## WILLARD COURT SUBDIVISION

APPLICATION NUMBER 3 DATE April 19, 2007

REQUEST Subdivision

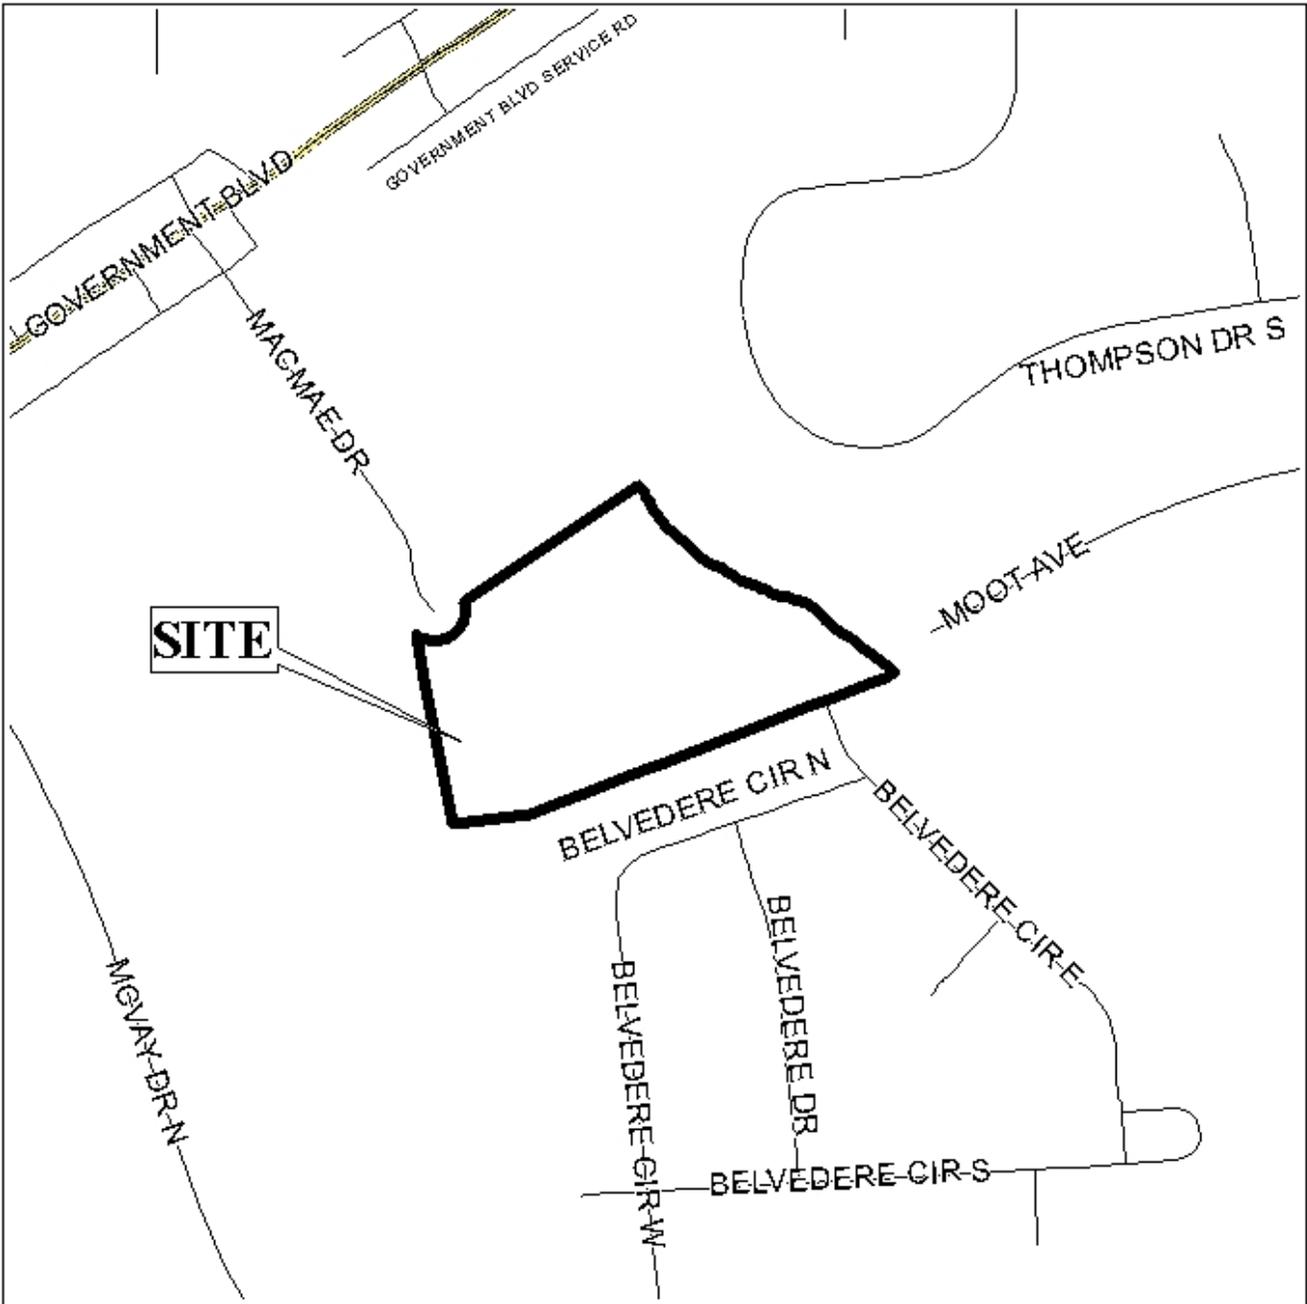
Engineering Comments: Delete note 4 on the plat (“*Flood zones platted from elevations.*”). Flood zones should be clearly delineated on the plat based on scaling the flood zone from FEMA maps, not based on elevation. Show minimum finished floor elevation on each lot. Must comply with all storm water and flood control ordinances. Any work performed in the right of way will require a right of way permit.

MacMae Drive is a minor street, but access management is a concern due to the limited frontage of each lot on the cul-de-sac. A note should be placed on the plat, if approved, stating that each lot is limited to one curb-cut onto MacMae Drive, with the size, design and location to be approved by Traffic Engineering and conform to AASHTO standards. All lots should be denied access to Belvedere Circle East and Moot Avenue.

If the proposed ingress / egress easement is to allow joint access between two lots, the applicant should submit an application for Planned Unit Development prior to the signing of the final plat, if approved.

Finally, the dimension on the lot line between proposed Lots 1 and 2 is incorrect.

- 1) full compliance with Engineering comments [*Delete note 4 on the plat (“Flood zones platted from elevations.”). Flood zones should be clearly delineated on the plat based on scaling the flood zone from FEMA maps, not based on elevation. Show minimum finished floor elevation on each lot. Must comply with all storm water and flood control ordinances. Any work performed in the right of way will require a right of way permit.*];
- 2) depiction of the size of each lot in square feet on the final plat;

- 5) placement of a note on the plat stating that each lot is limited to one curb-cut each onto MacMae Drive, with the size, design and location to be approved by Traffic Engineering and conform to AASHTO standards;

- 6) placement of a note on the plat stating that all lots are denied access to Belvedere Circle East and Moot Avenue;
- 7) submittal of an application for PUD to accommodate any shared access between Lots 2 and 3 that is depicted as an easement on the plat;

- 8) correction of the distance depicted on the lot line separating Lots 1 and 2; and
- 9) full compliance with all other municipal codes and ordinances.
